12.3**Directorate****Director****Manager****Attachment(s)****Application P392/2023 for Approval of a Development Plan Under Development Plan Overlay 16 for 179 Tilburn Road, Deer Park and surrounding land**

For Council to consider an assessment of Application P392/20203 for approval of a development plan under Development Plan Overlay Schedule 16 at 179 Tilburn Road (previously known as 765 Ballarat Road), Deer Park and surrounding land.

That Council approves the Development Plan for 179 Tilburn Road, Deer Park and surrounding land, subject to the incorporation of changes specified in Attachment 7 to this report.

Image 8: Image showing variable creek buffers

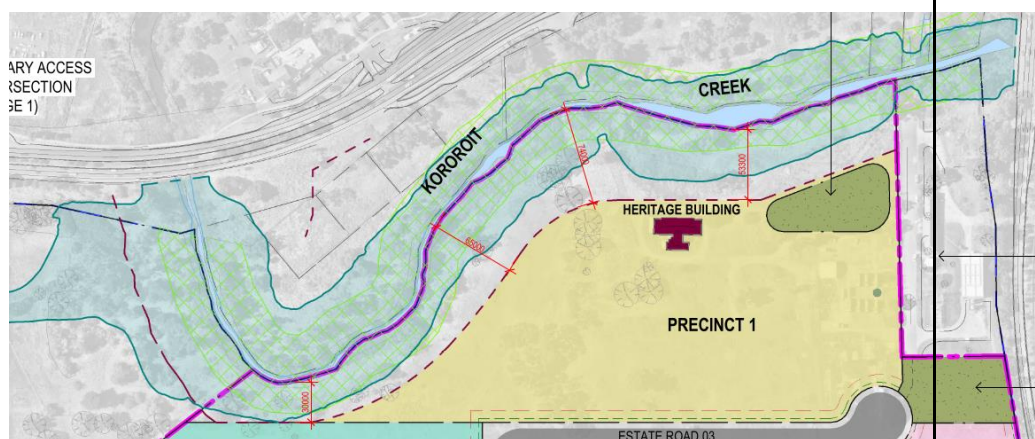
- Regarding the request for the setbacks for development from Kororoit Creek to be increased to a minimum of 50 metres, the applicant has provided a *Variable Creek Buffer Plan* below (received on 5 July 2024) with Melbourne Water having no objection to the approach:

It is unclear how the average setback will be achieved particularly if the area adjoining the Creek interface is subject to a number of future applications. The following modifications to the development plan are recommended to be required as conditions of approval:

12. The Variable Creek Buffer Plan (P105.02.24) received by Council on 5 July 2024 must be included as part of the Development Plan.
